Rezoning Application: PD 24-0142
Zoning Hearing Master Date: February 20, 2024
BOCC Land Use Meeting Date: April 9, 2024

AGENCY REVIEW COMMENT SHEET

PETITION NO: PD 24-0142

2.4 Proposed Site Plan (partial provided below for size and orientation purposes. See Section 8.0 for full site plan)

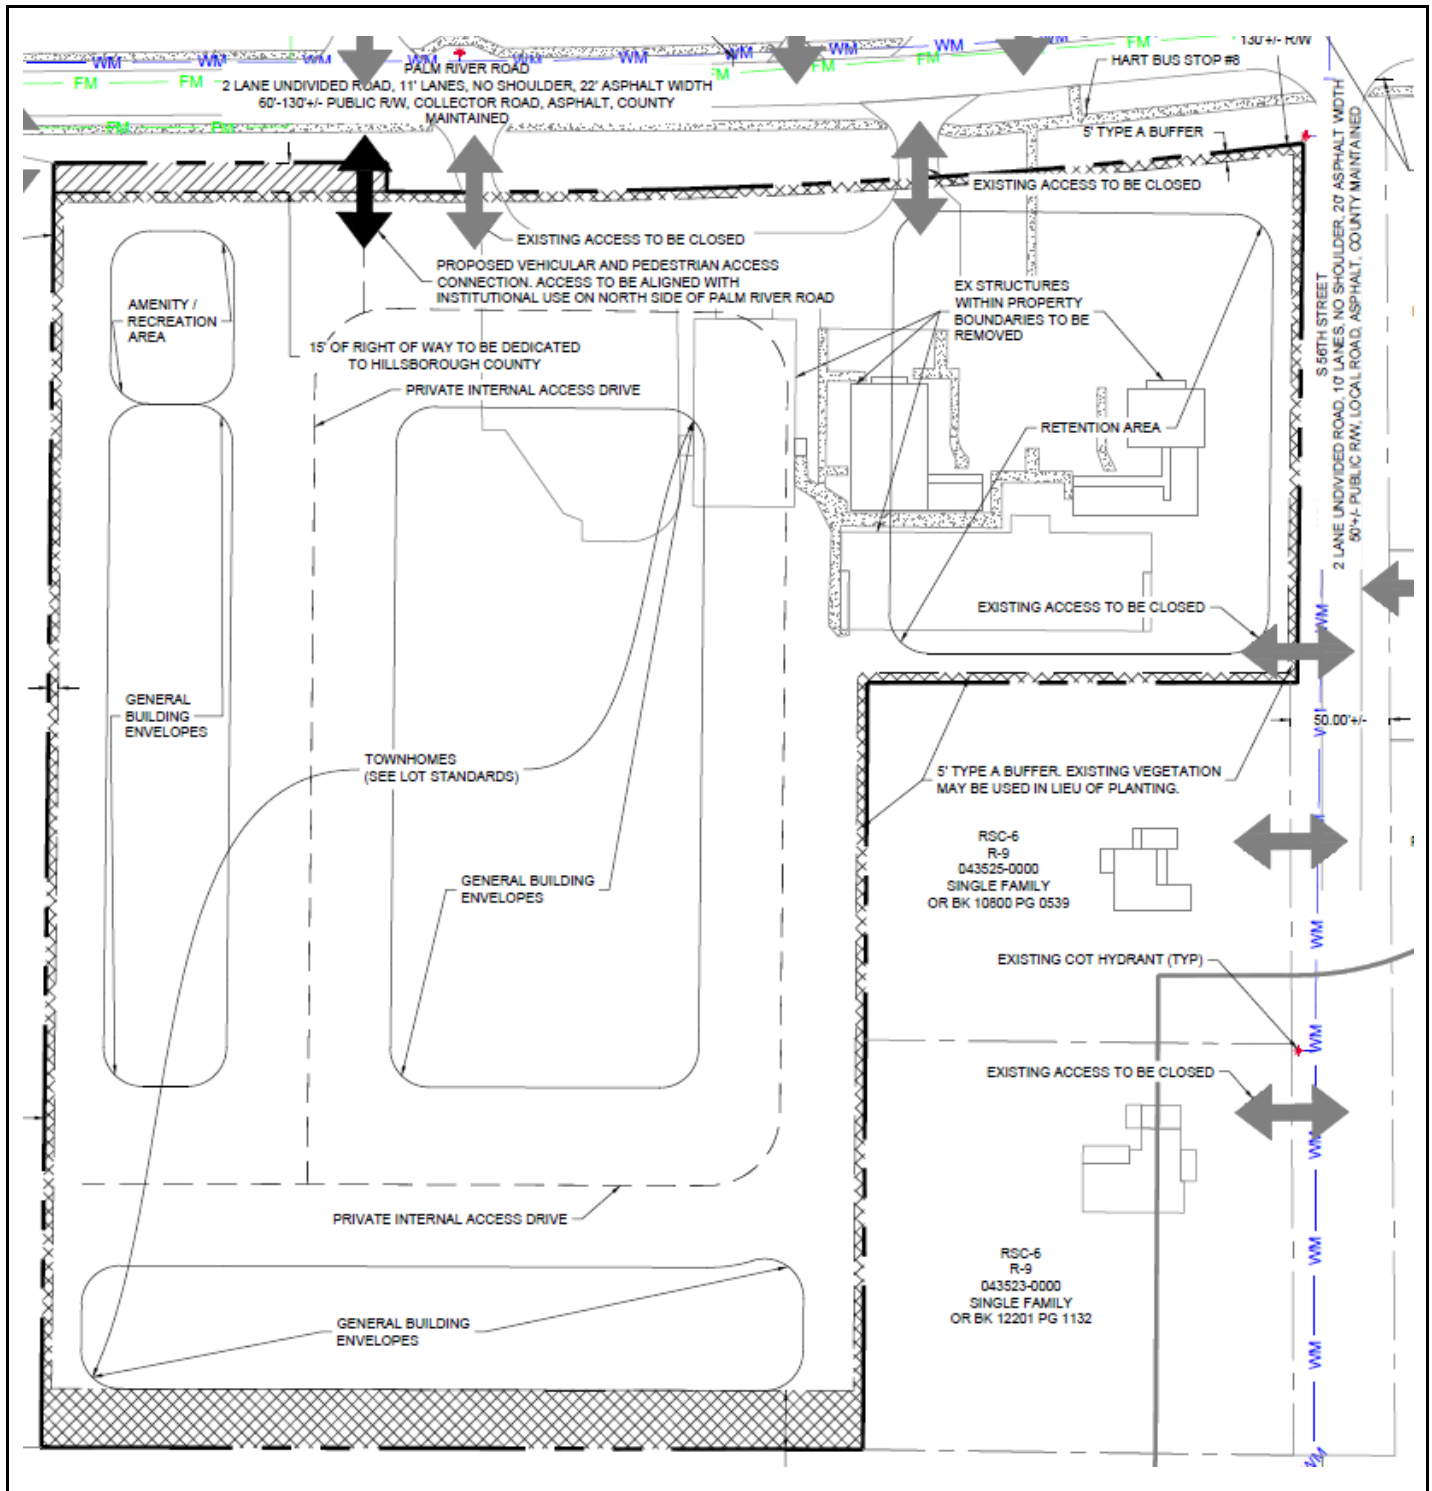
Prior to certification, the applicant shall revise the Typical Townhome Detail to:

- 1) require a minimum 20' front setback, and
- 2) add a footnote that states "If a driveway is located in the side yard, a minimum 20' setback will be required."
- 3) Revise the Site Plan to replace notations of 5' TYPE A BUFFER. EXISTING VEGETATION MAY BE USED IN LIEU OF PLANTING and revise to reflect a 10' Type "A" Buffer.

Prior to certification, the applicant shall revise Typical Townhome Detail to:

- A) require a minimum 20' front setback, and
- B) add a footnote that states "If a driveway is located in the side yard, a minimum 20' setback will be required."

The proposed PD site plan includes a Typical Townhome Detail that allows for 18-foot setbacks from the building façade/garage door to the back of sidewalk. Based on based on the County Transportation Technical Manual, Parking Configuration Typical Detail (TD-2) 20’ (C) *minimum stall to wall* to accommodate standard vehicles in the driveway, County Land Development Code, Section. 6.05.02 residential parking requirements, and LDC, Sec. 6.03.02.A. site plan sidewalks “*to provide for safe pedestrian circulation*” a minimum of 20 feet shall be provided in order to not obstruct the path of pedestrians using the internal sidewalks while vehicles are parked in the driveway. Staff has included a prior to certification required to revise the Typical Townhome Detail accordingly.
